Notes from the 5001 Stateroom Mock-up

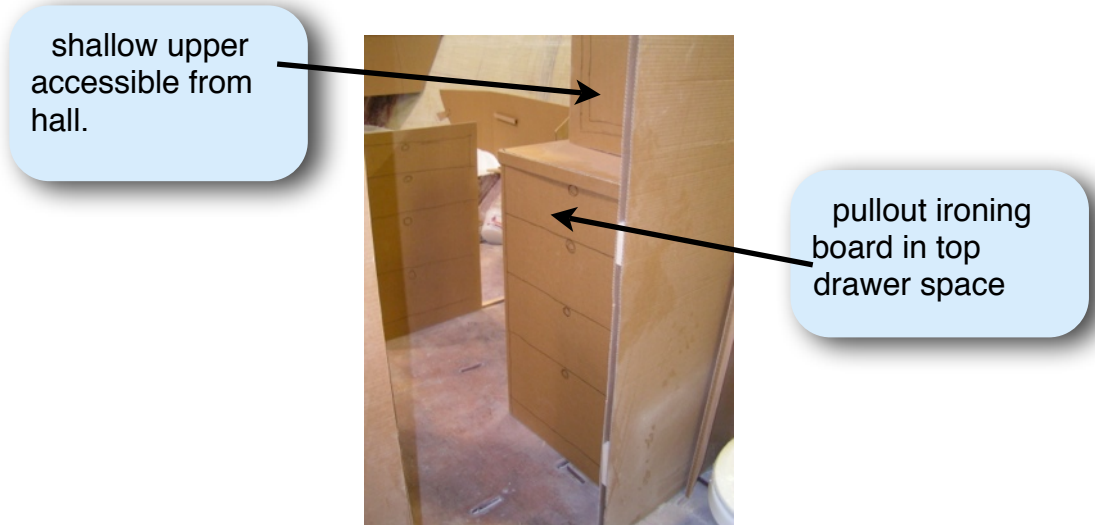
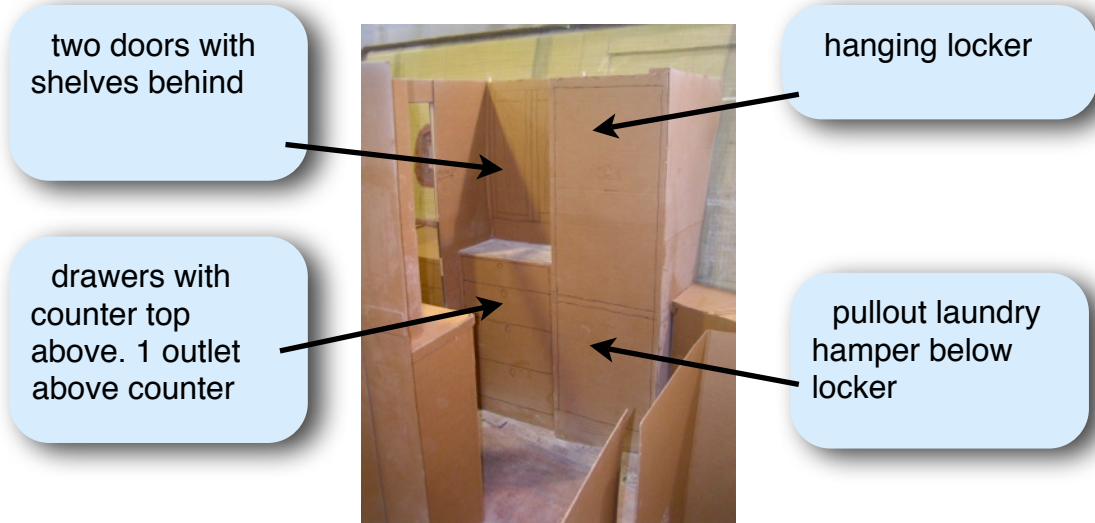
If possible lower top of the mattress to the same height as side cabinets, some loss of width at the forward end is acceptable.

The seat is now on the port side

The doors on the cabinets above the headboard will be built to accommodate a glass panel that will be provided by the owners. A Blue Heron done in stained glass was suggested. Jan recommended the same glass artist that made the fused glass for the 01 boat.

The headboard will be about 20 inches high and in three panels. The center section will hinge down giving access to storage. The fabric and look of these panels needs to be determined.

The shelf will also act as a step to help access the emergency escape hatch. This will limit lights, art pieces etcetera as to not limit escape. Sundi has samples of low profile swing arm reading lights.

Hanging lockers are split horizontally at about 37 in. from deck. Hanging space is at top on both sides. The port lower is a pullout laundry hamper and the starboard lower is 3 pullout shelves with a door. The starboard locker should be moved out from the centerline to the same distance as the port side.

Outboard dresser is drawers below with shelves behind doors above.

Inboard dresser has drawers below and a shallow cabinet above with a pair of doors in hallway. It was suggested that the back side of the upper would be a good location for a mirror. There will be a Hafele Ironfix ironing board behind the top drawer face. There should be an outlet in this area for an iron.

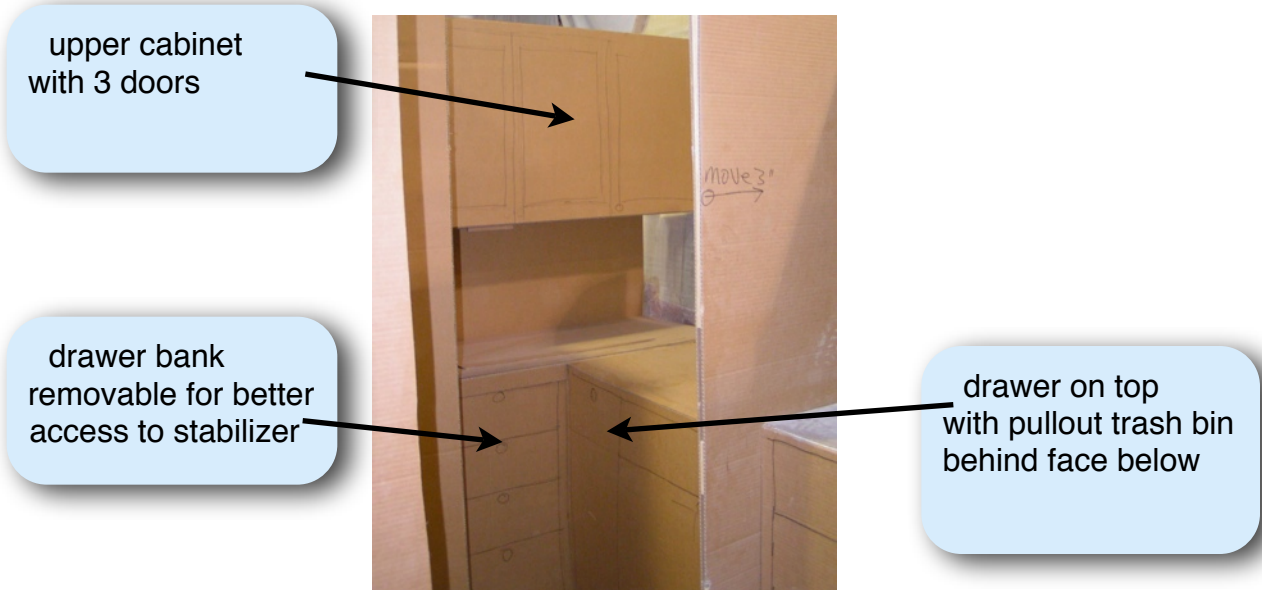
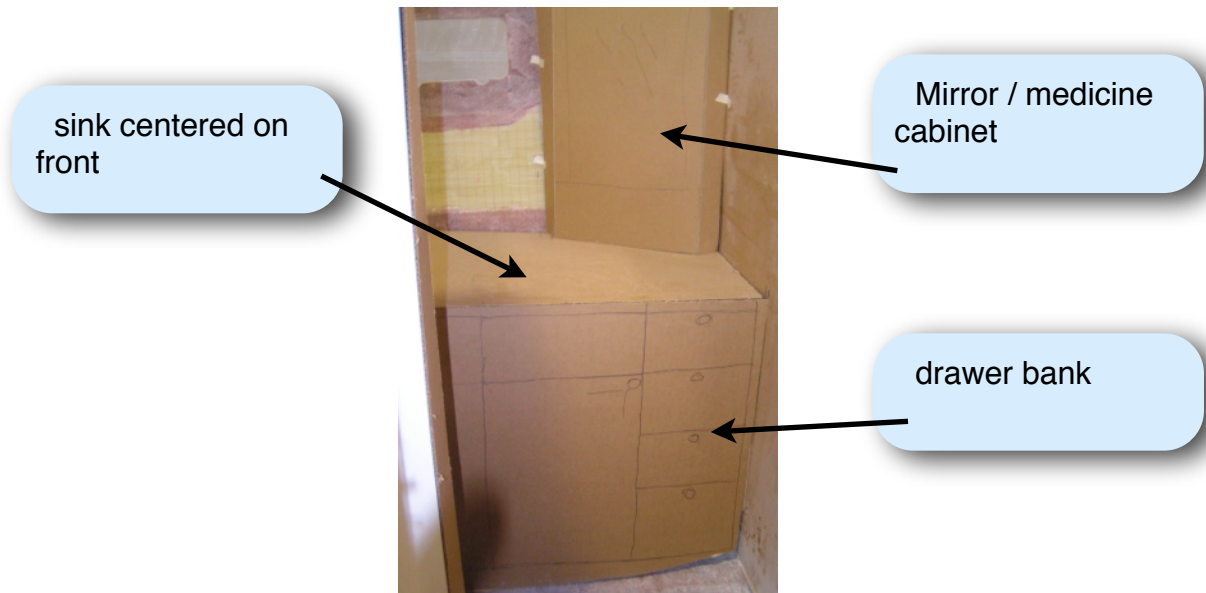
The door to the head will be moved outboard 2 to 3 inches.

Medicine cabinet angle towards person standing in front of sink, storage behind mirror.

Sink centered on cabinet front.

Drawer bank on forward end of cabinet, false front and door at center and drawer on top and door face with trash bin below at aft.

Upper cabinet with 3 doors. Cabinet is about 12 inches deep and 18 inches above counter top.

Drawer bank on lower aft with drawer sizes matching forward drawer bank. Drawer bank to be removable for access to stabilizer.
